**AGENDA**  
**CITY OF THE DALLES**  
**HISTORIC LANDMARKS COMMISSION**

**A. Historic Landmarks Commission Application #138-13 – The Dalles Mural Society;**  
Request to gain approval to install outdoor lighting on four (4) murals located in various areas on Federal Street. Properties are located at the following addresses: 400 E. 2<sup>nd</sup> St. (Honald) and is further described as 1N 13E 3BD t.l. 5300; 312 E. 2<sup>nd</sup> St. (Dong Xi) and is further described as 1N 13E 3BD t.l. 5200; 401 E. 2<sup>nd</sup> St. (Anthony Foote) and is further described as 1N 13E 3BD t.l. 2300; 319 E. 2<sup>nd</sup> St. (James Craig) and is further described as 1N 13E 3BC t.l. 2400. The Property is zoned “CBC” – Central Business Commercial.

**B. Historic Landmarks Commission Application #139-13 – Fort Dalles Museum;**  
Request to gain approval to install gutters on the north and south sides of the Anderson House in order to prevent further decay to the wooden house structure. The property is located at 500 W. 15<sup>th</sup> Street and is further described as 1N 13E 4DB t.l. 10400. Property is zoned “P/OS” – Parks and Open Space and is historically known as The Anderson Granary.

**STAFF REP

PROJECT: Riverfront Interpretive Signs (13175)  
SHEET 1 OF 8

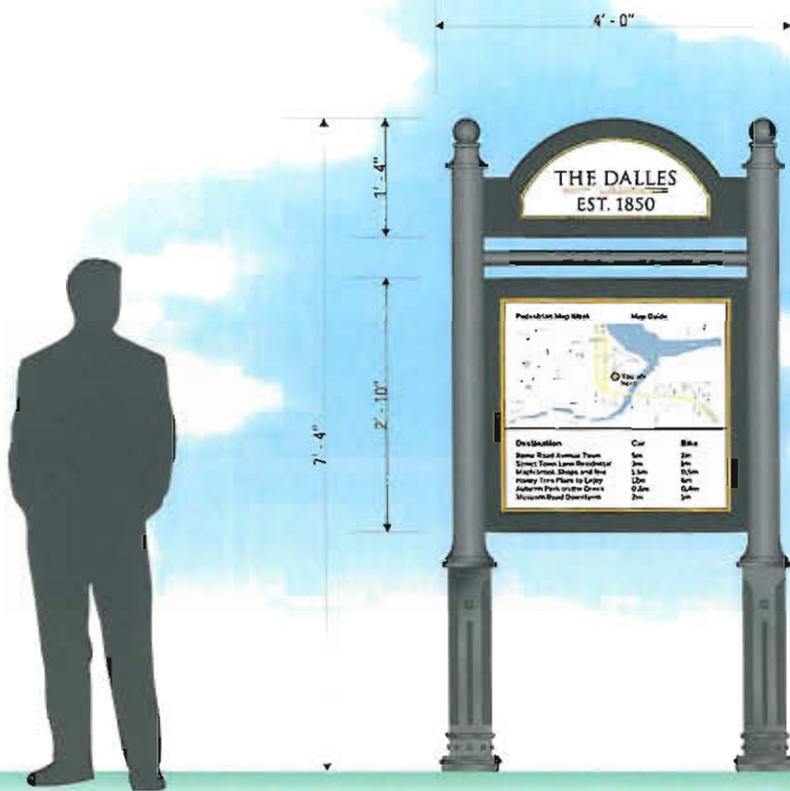
Senior Planner Hert pointed out that the design on sheet #5 had a similar style to the City's streetlights. Parker stated that she liked the design on sheet #1 because it was similar to the arch design on the

Union Street Underpass. Davis suggested combining the base design illustrated on sheet #5 base with the sign design on sheet #1. Administrative Fellow Chrostek suggested the lighting feature shown on sheet #2 could also be incorporated.
